Limited Visual Dam Safety Inspection Summary Report

MA-055

Wahikuli Reservoir

May 2006

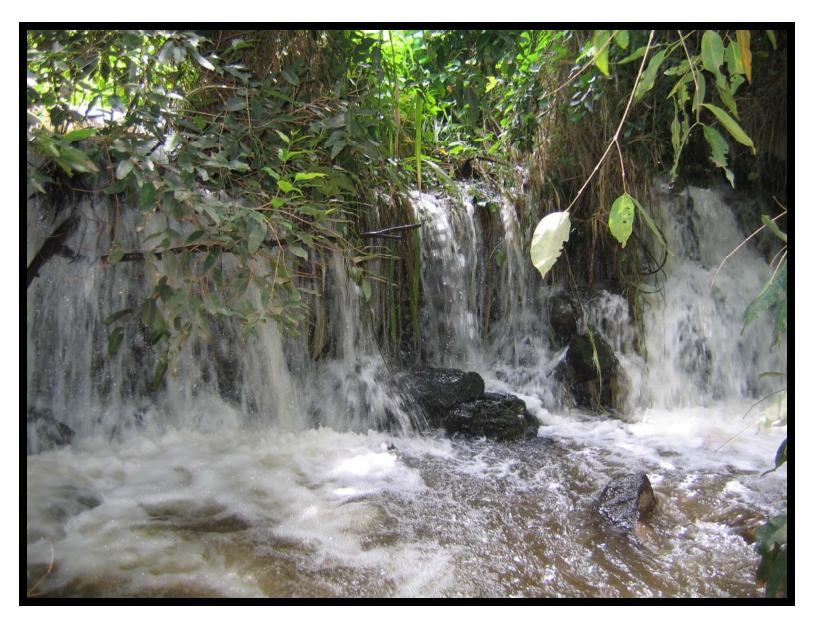
Heavy growth needs to be removed to promote visual inspection of slopes, particularly at the spillway.

Minor sloughing/slide (10 ft) or less near the toe along the north side of the downstream embankment should be further evaluated.
